Indian Point Units License Renewal

Presentation by Karl Jacobs

Indian Point Unit 1 License Renewal Scoping Issues

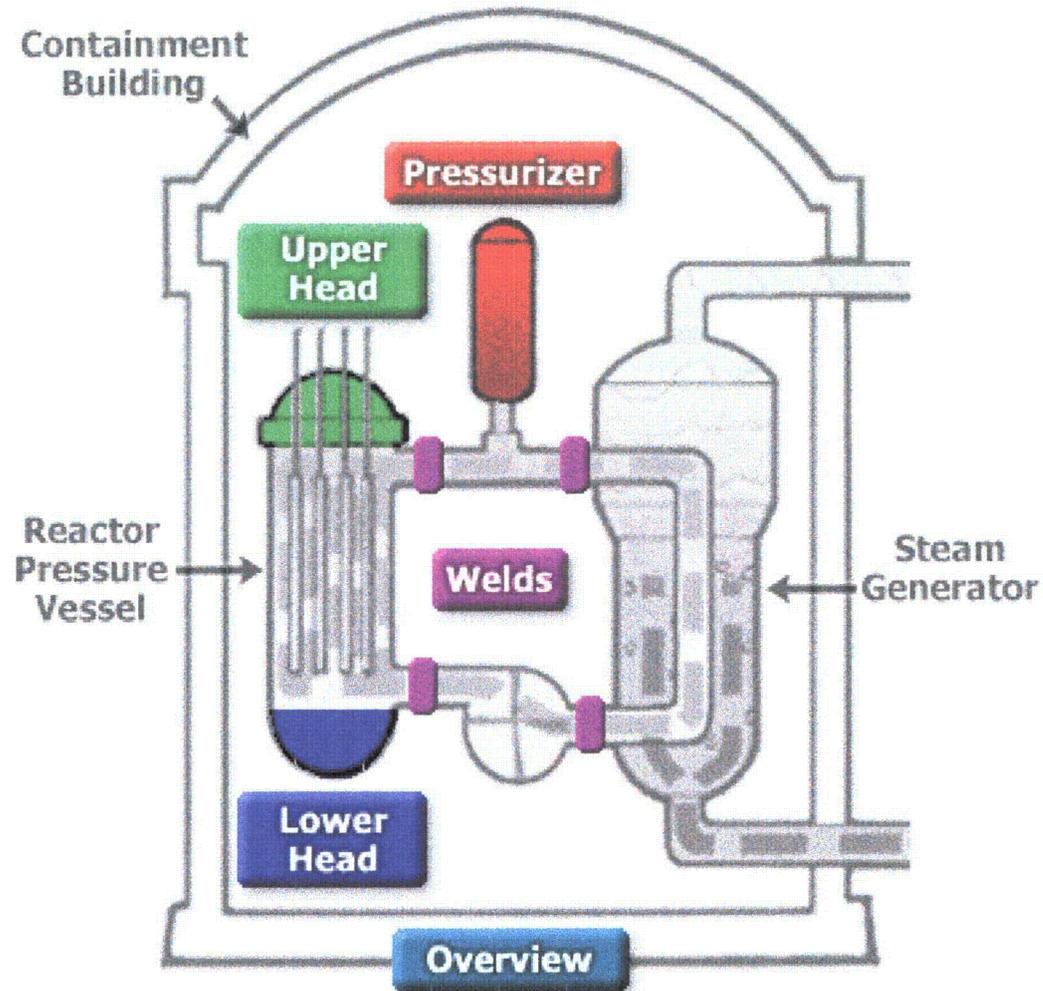
A review of the scoping of components in the LRA the does not identify Indian Point Unit 1 Containment structure and spent fuel systems and their support systems as being part of the License Renewal Application. See LRA Section 2.4.1 Describes only Unit 2 and Unit 3 Vapor Containment Structure. Unit 1 containment structure is omitted.

Per the License Renewal Application for IP2 and IP3 under containment scoping and screening review in section 2.4.1 page 2.4.-2 state “the containment buildings have the following intended functions for 10CFR54.4(a)(1), (a)(2) and (a)(3).”

- Provide support, shelter and protection for safety- related equipment**
- Maintain essential leak tight barrier**
- Maintain integrity such that safety –related equipment is not affected.**

Indian Point Unit 1 supports the spent fuel cooling system is located in the containment structure. IP Unit 1's containment performs intended functions as defined by the License Renewal rule function above. In addition other scoping of license renewal scoping and screening systems are inside the containment structure that have been excluded are spent fuel pools structures; HVAC filtration for radioactive airborne particulates, containment penetrations, spent fuel pool system cooling piping and their supports, spent fuel cooling pumps, instrumentation for monitoring the operations of the spent fuel system, electrical wiring, spent fuel bridge, cranes and radiation monitors etc.

PZR

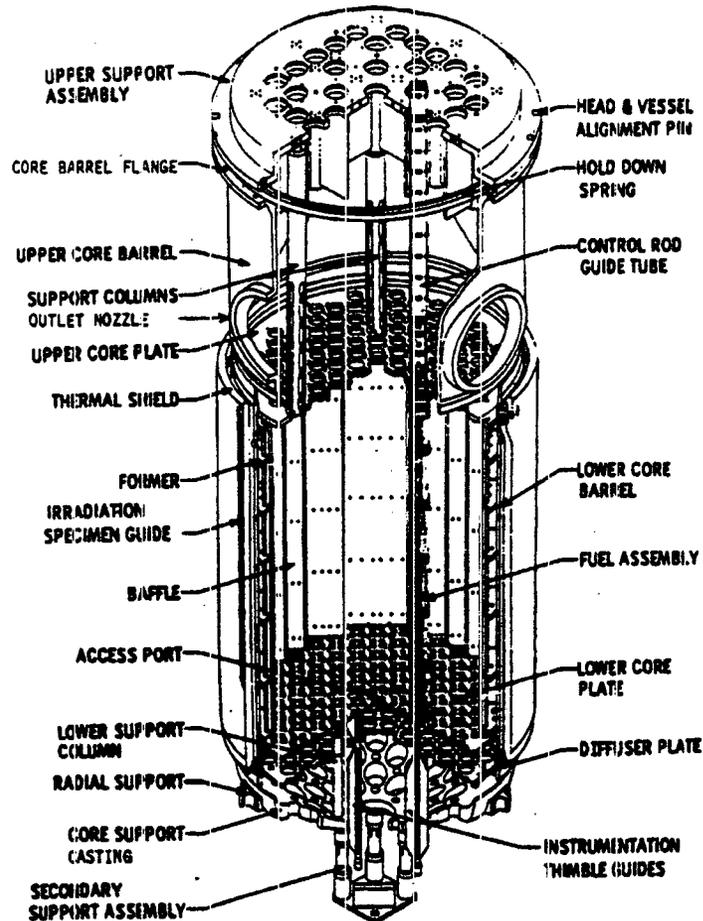
- **Aging Degradation mechanisms for the IP 2 and IP3 Pressurizers are so significant that replacement is the only option for License Renewal. Some Highlights**

- **The pressure boundary materials of the Pressurizer are susceptible to Primary Water Stress Corrosion Cracking (PWSCC)**
 - ❖ **The pressurizer has Inconel 82/182 weld metal in pressurizer safety, relief, spray and surge nozzles which is susceptible cracking due to PWSCC**

- **The pressure boundary materials of the Pressurizer have significant end of life fatigue issues that will not meet life extension time frame**
 - ❖ **Fatigue of the upper portion of the pressurizer shell (44 years), the spray nozzle(49 years), the manway bolts (46 years), the seismic support lugs(41 years), lower head (due to insurge/outsurge transients), the heater wells (due to insurge and outsurge transients), the surge nozzle, the support skirt and flange (skirt –to-lower-head weld 54 years).**

- ❖ **Then when you impose the NRC environmental effect to the fatigue calculations the list gets longer. Lower head (42 years), the safety and relief nozzles (53 years) and instrument nozzles (51 years)**

- ❖ **Aging Management Program 2.3 needs to be imposed. This states that if the TLAA can not show acceptable usage for the license renewal period, the fatigue adequacy will be met by implementing a repair and replacement program in accordance with ASDE Section XI IWA- 004000 or IWA-7000**

Upper Head Aging Parts that require Aging Management Efforts

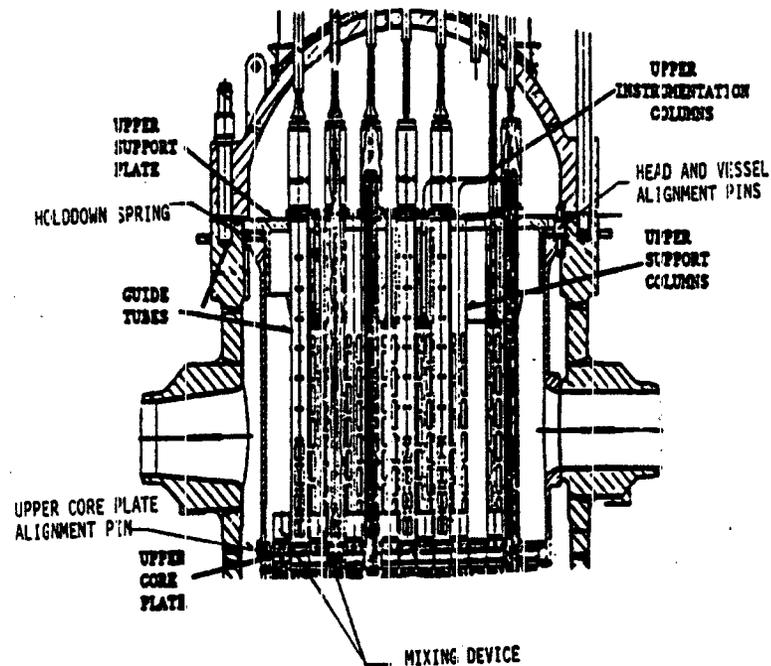
- **Guide Tubes (Guide Tubes) – Wear**
- **Control Rods – Wear, Cracking -**
- **GT Flexure Replacement for IP Unit 2- Original Flexures are susceptible to SCC**
- **Split Pins – Stress Corrosion Cracking**
